Access Compliance Report

Public Rights-of-Way

(Curb Ramps)

Intersection ID: 10228	Main Street: E_35TH_ST	Cross Street: N_ALEXANDER_ST	Location: S
ADA ID: 7F6FC84AD837	Ramp Type: Perp	Initial Pass/Fail: Fail	Overall Compliance: No
Severity Score: 26.25			
Codes/Mitigation Info/Possible Solution		Field Measurements/Component Compliance

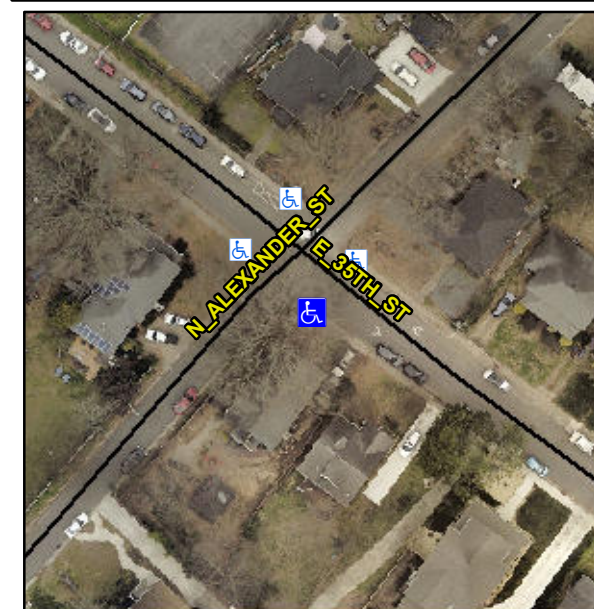
R304.2.2, R304.5.3

Compliance	Description	Data	Compliance	Description	Data
N/A	Ramp Length (in)	47.0	No	Ramp Slope (%)	14.0
Yes	Ramp Width (in)	48.0	No	Ramp XSlope (%)	2.1
N/A	Flare Type LT	N/A	N/A	Flare Type RT	N/A
N/A	Flare Slope LT (%)	N/A	N/A	Flare Slope RT (%)	N/A
N/A	Flare Traversable LT?	N/A	N/A	Flare Traversable RT?	N/A
N/A	Landing Length (in)	N/A	N/A	DWS Provided?	N/A
N/A	Landing Width (in)	N/A	N/A	DWS Contrast?	N/A
N/A	Landing Slope (%)	N/A	N/A	DWS Length (in)	N/A
N/A	Landing X Slope (%)	N/A	N/A	DWS Full Width?	N/A
N/A	Landing Curb? (Y/N)	N/A	N/A	DWS Offset (in)	N/A
N/A	Shared Landing?	N/A			
N/A	Gutter Ponding?	N/A	N/A	Gutter Slope (%)	N/A
N/A	Gutter Lip Ht (in)	N/A	N/A	Gutter X Slope (%)	N/A
N/A	Painted X Walk1?	No	N/A	Painted X Walk2?	N/A
	X Walk 1 Direction	To NW		X Walk 2 Direction	N/A
N/A	X Walk 1 Width (in)	N/A	N/A	X Walk 2 Width (in)	N/A
	X Walk 1 Slope (%)	0.1		X Walk 2 Slope (%)	N/A
	X Walk 1 X Slope (%)	3.3		X Walk 2 X Slope (%)	N/A

Remove & Replace Entire Ramp.
